AGENDA PORTLAND PLANNING BOARD MEETING

- i. Major Site Plan and Subdivision; 385 Congress Street; Fathom Congress, LLC., Applicant. (estimated time 4:30 – 6:00 pm) The Planning board will hold a remote workshop to consider the first project phase of the Master Development Plan for 385 Congress St., approved by the Planning Board on August 9, 2022. The program for this phase includes an 11 story, 167,345 square foot building with 156 hotel rooms, nine upper-floor condominium units, structured and surface parking and a plaza for public use. The subject property is 2.26 acres and zoned B-3

To: Chair Stanley and Members of the Portland Planning Board
From: Zach Powell, Senior Planner
Date: October 21, 2022
Re: Herald Square (Phase 1 of 385 Congress Street Master Development Plan)
Applicant: Fathom Congress, LLC
Project ID: PL-002156-2022
Meeting Date: October 25, 2022

10. *Are you aware of the tunnel under Congress Street?*

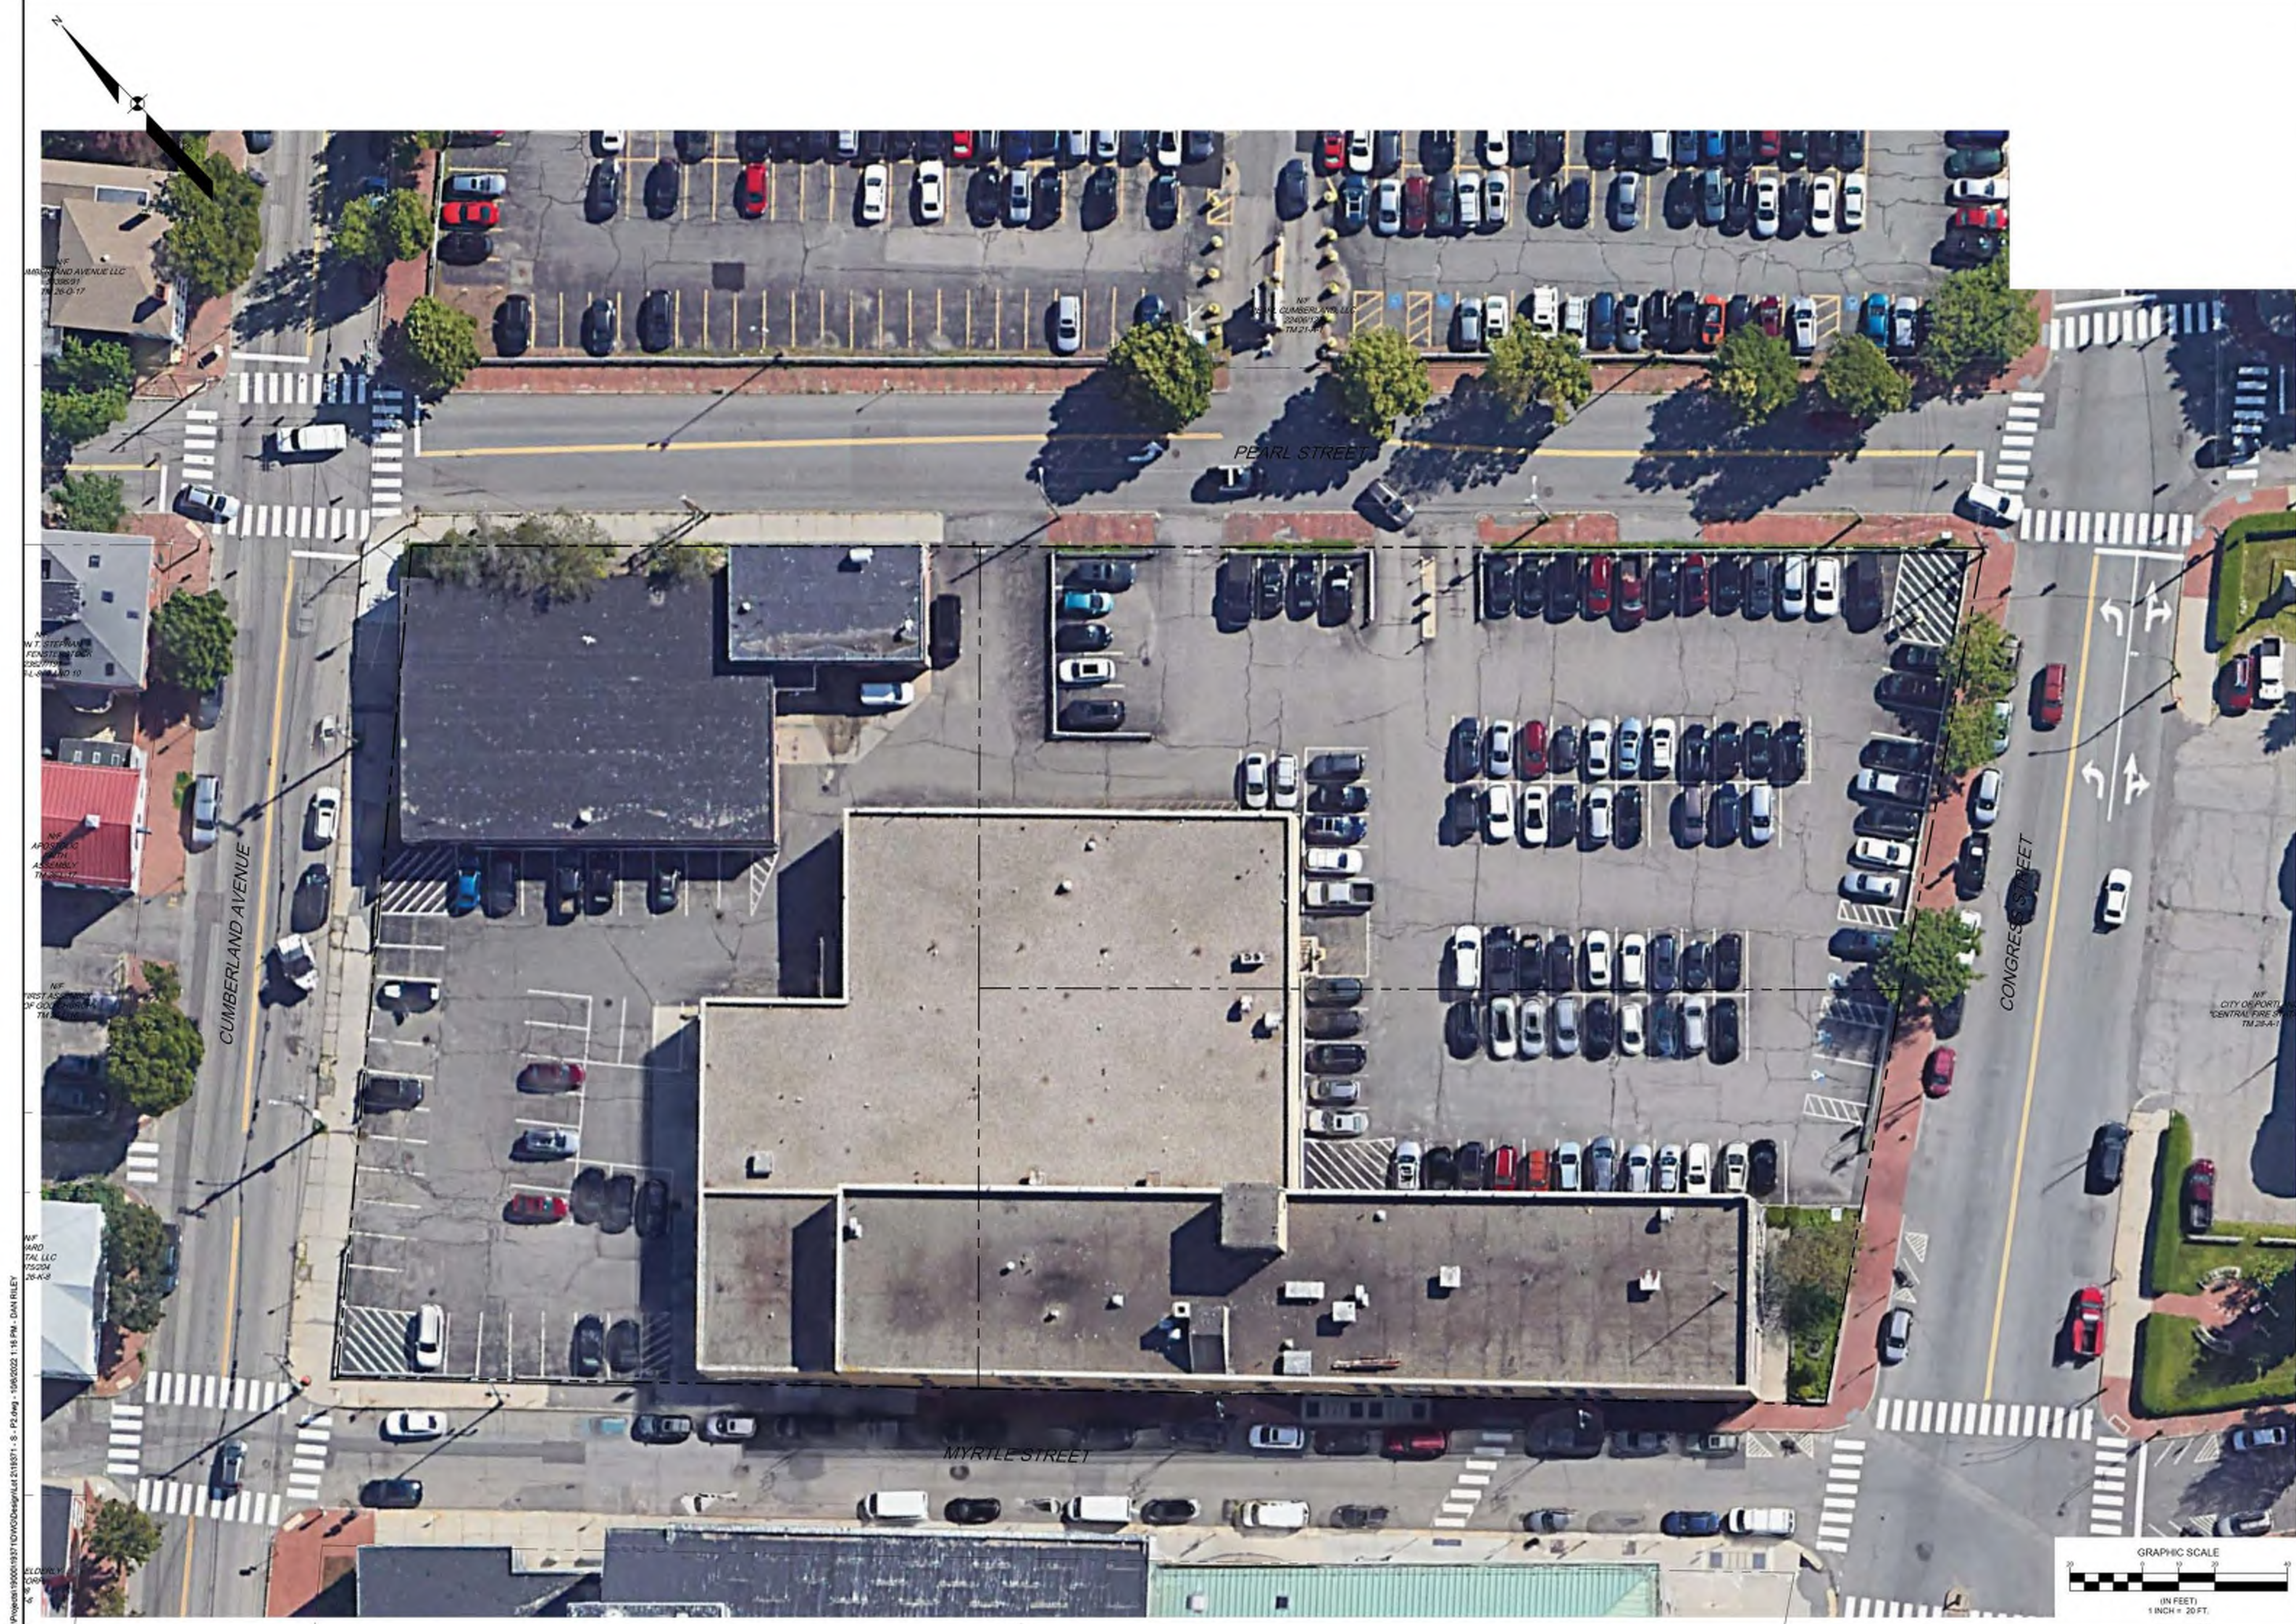
- *The overall site plan calls out for an existing tunnel crossing Congress Street near the intersection with Myrtle to remain. The approved MDP had a note which said the tunnel was to be removed. Further discussion with the Department of Public Works and City staff will be required regarding the outcome of this existing tunnel.*

Yes, we are. There is no plan to continue the use of the tunnel.

SOUTH ELEVATION - MYRTLE STREET
3/32" = 1'-0"

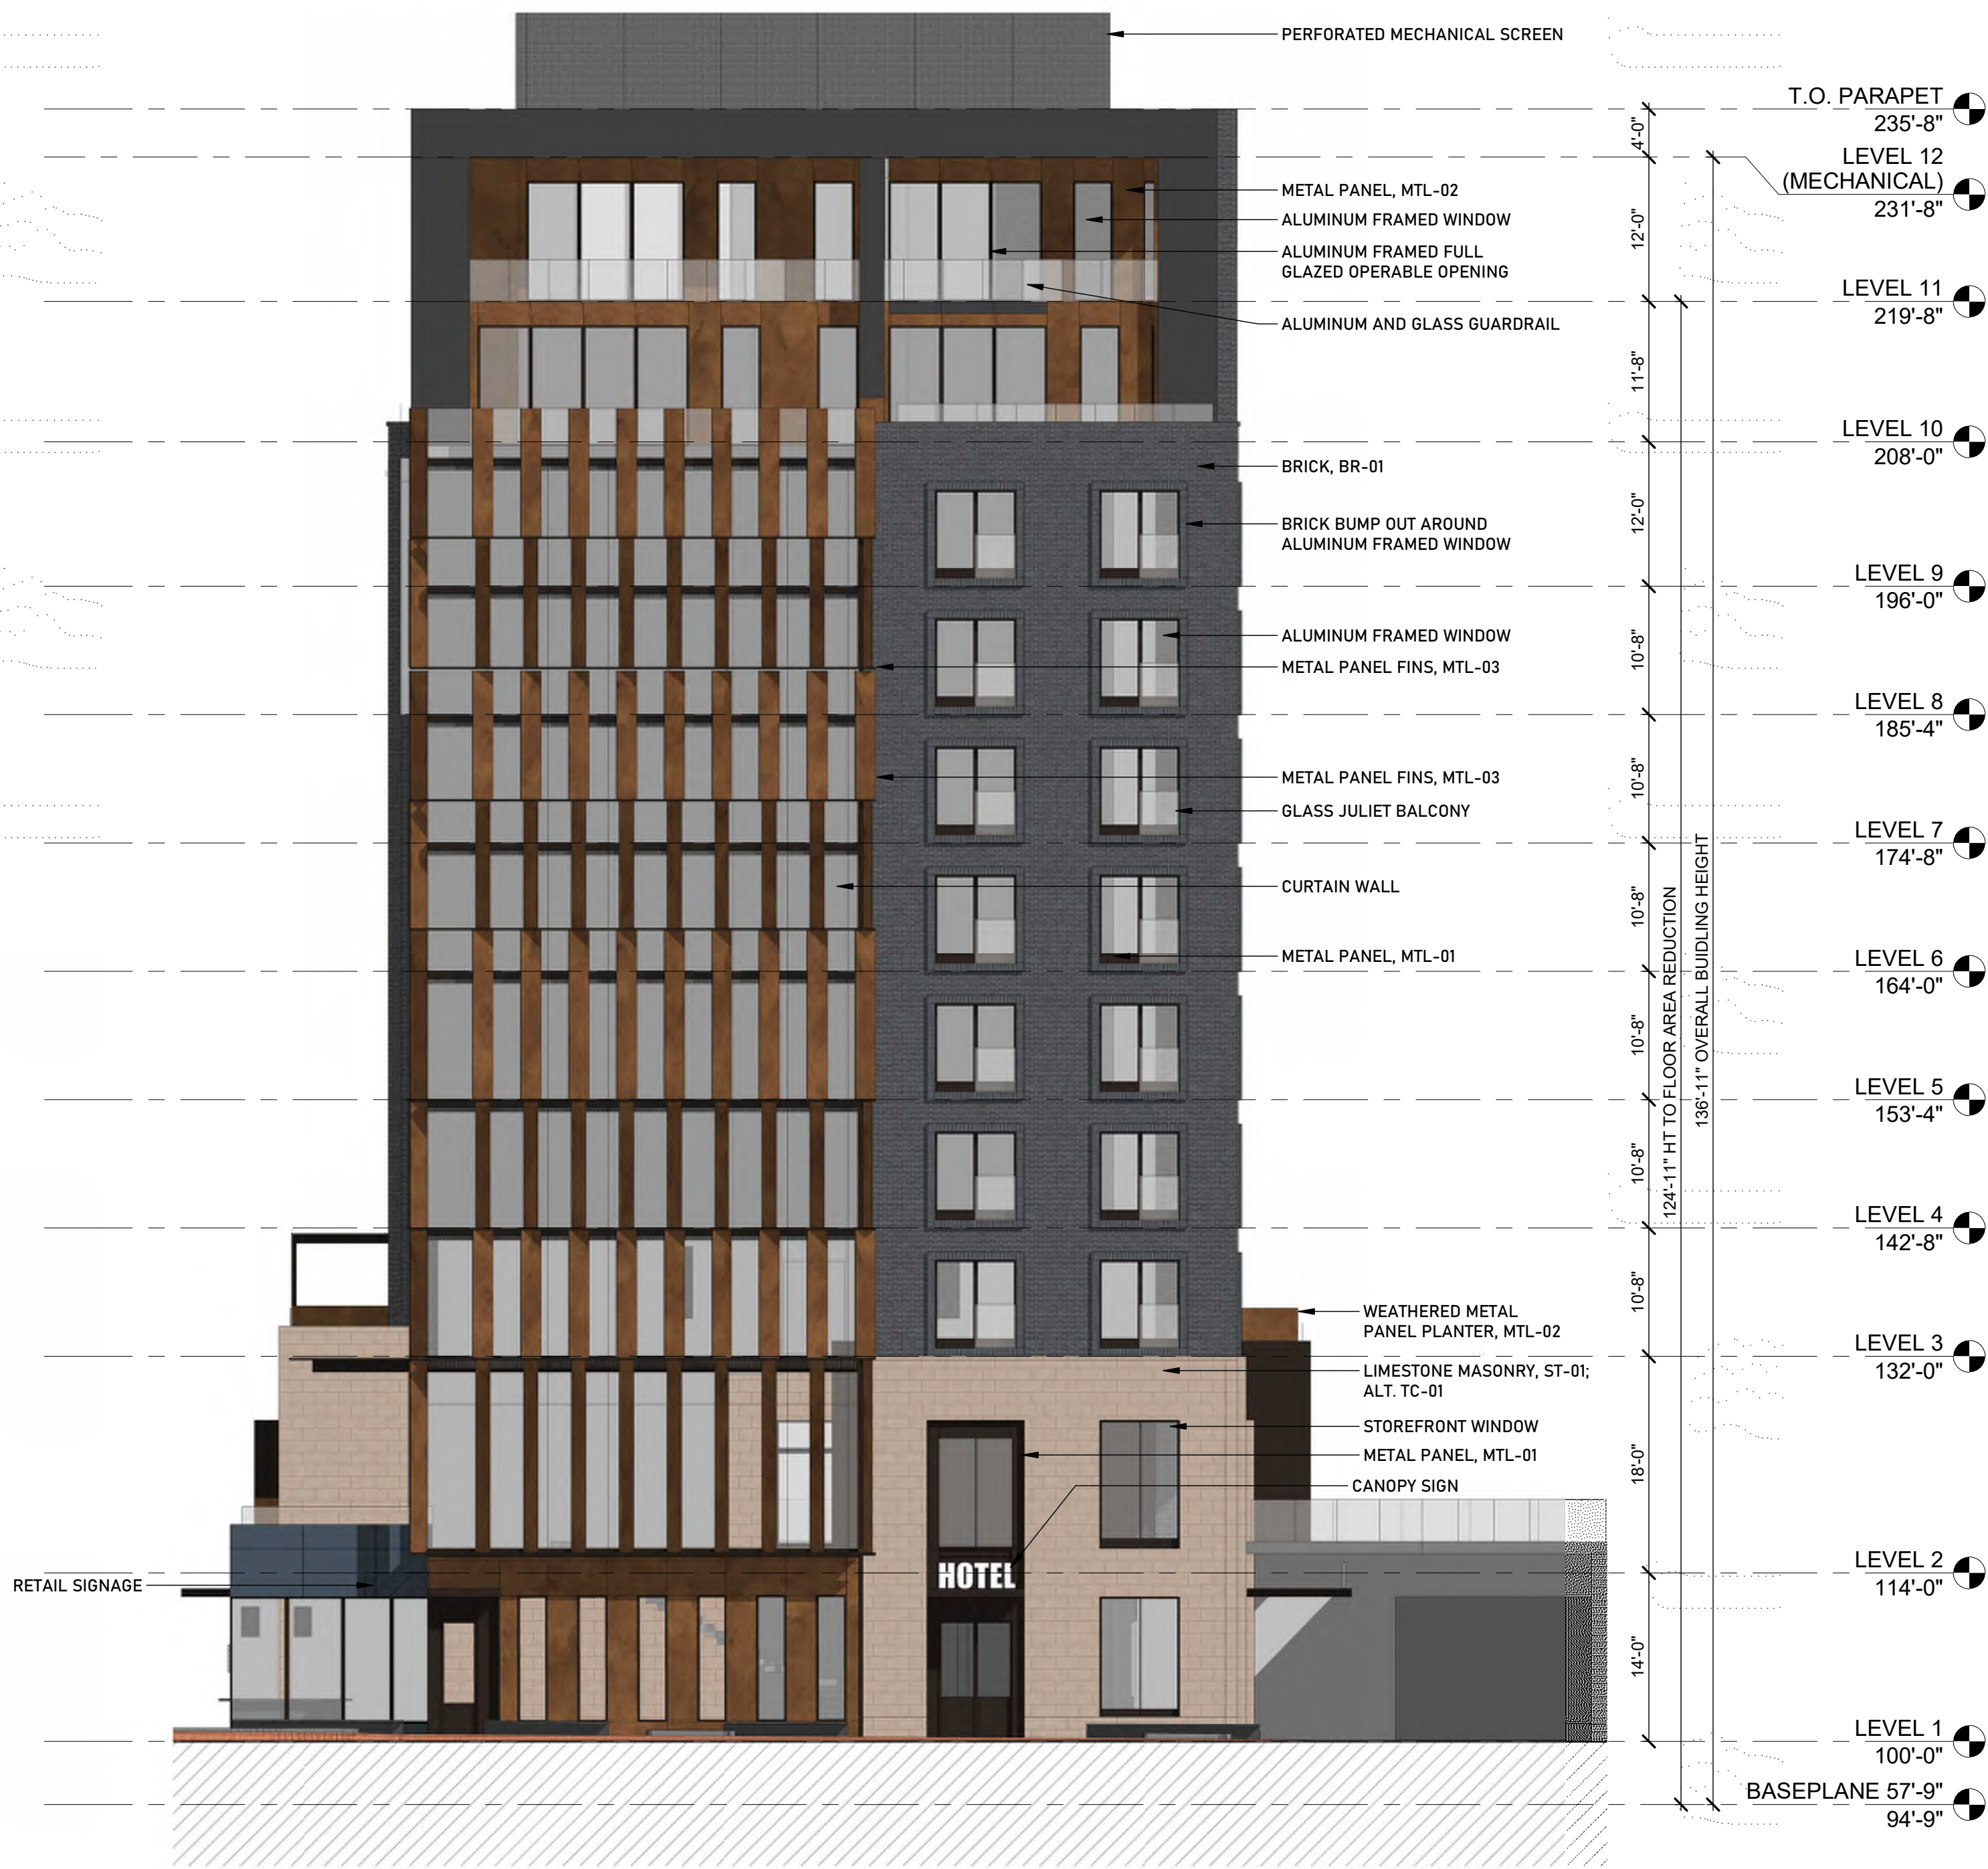
the maximum permitted undifferentiated wall space. The interim conditions for the base of the podium and the Myrtle Street elevation (P. 35) exceed the maximum 30 feet, as well as the rightmost portion of the second floor on Myrtle Street & the proposed elevator tower. As further discussed in Section IX, green wall treatments or murals would provide simple solutions to address compliance with this standard.
